Item Name: Crosstube Turning Detail

DART AEROSPACE LTD	Work Order:	88786
Description: Crosstube Assembly (412 High Aft)	Part Number:	D412-664-243
Inspection Dwg: D412-664-243 Rev: E		Page 1 of 2

DRAWING NO. D412-664-243	TITLE CROSSTUBE ASSEMBLY (412 HI AFT)	REV. E	DART AEROSPACE LTD ENGINEERING ORDER		D.E.O. NO. D412-664-243-E-1	SHEET NO. SHEET 1 OF 2	SCALE NTS
DRAWN	CHECKED	MFG. APPR.	APPROVED	DE APPR.			
DATE 11.03.31	DATE 11/03.31	DATE 11.03.31	DATE 11/03.31	DATE 11.03.31

DRAWING NO. D412-664-243	TITLE CROSSTUBE ASS'Y (412 HI AFT)	REV. E	DART AEROSPACE LTD ENGINEERING ORDER		D.E.O. NO. D412-664-243-E-2	SHEET NO. SHEET 1 OF 1	SCALE NTS
DRAWN <i>MP</i>	CHECKED <i>ASS</i>	MFG. APPR. <i>EE</i>	APPROVED <i>MP</i>		DE APPR. <i>MP</i>		
DATE 11.09.07	DATE 11.09.19	DATE 11.09.19	DATE 11.09.19		DATE 11.09.19

D212-664-243
ASSEMBLY DETAIL

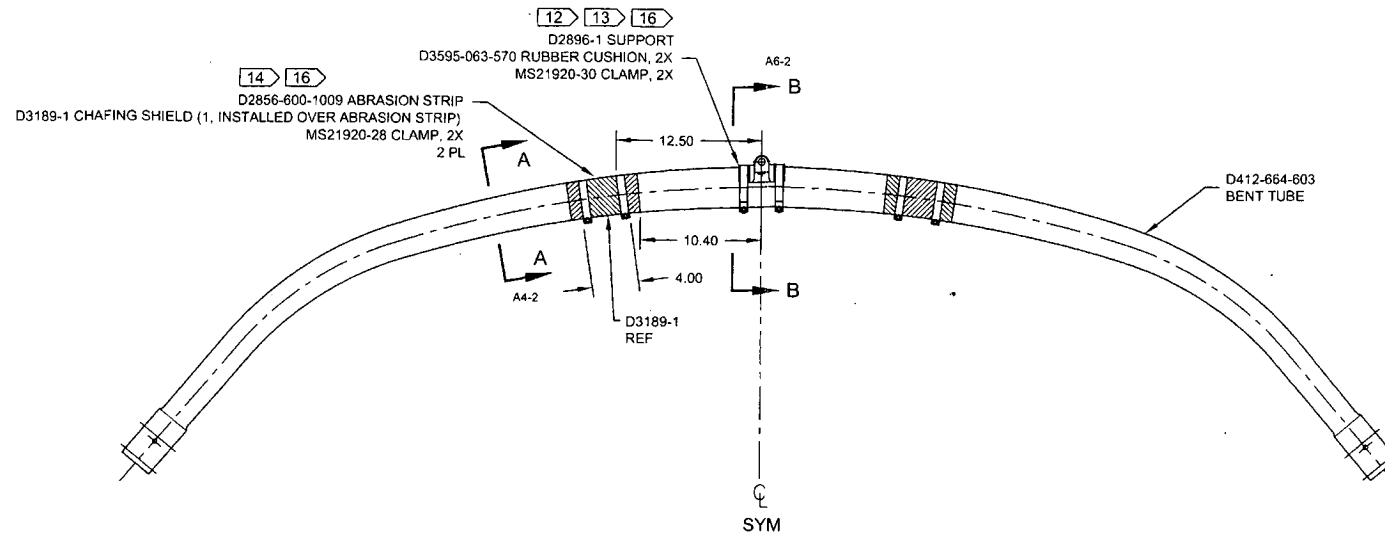
PURPOSE:

REMOVED ABRASION STRIP IN FAVOR OF A THIN LAYER OF PROSEAL 890.

IS:

D3189-1 CHAFING SHIELD (1, INSTALLED OVER PROSEAL 890)
MS21920-28 CLAMP, 2X
2 PL

WAS:

D2856-600-1009 ABRASION STRIP
D3189-1 CHAFING SHIELD (1, INSTALLED OVER ABRASION STRIP)
MS21920-28 CLAMP, 2X
2 PL

MASK AREA PRIOR TO PAINTING AND
APPLY CLEAR COAT AFTER PAINTING
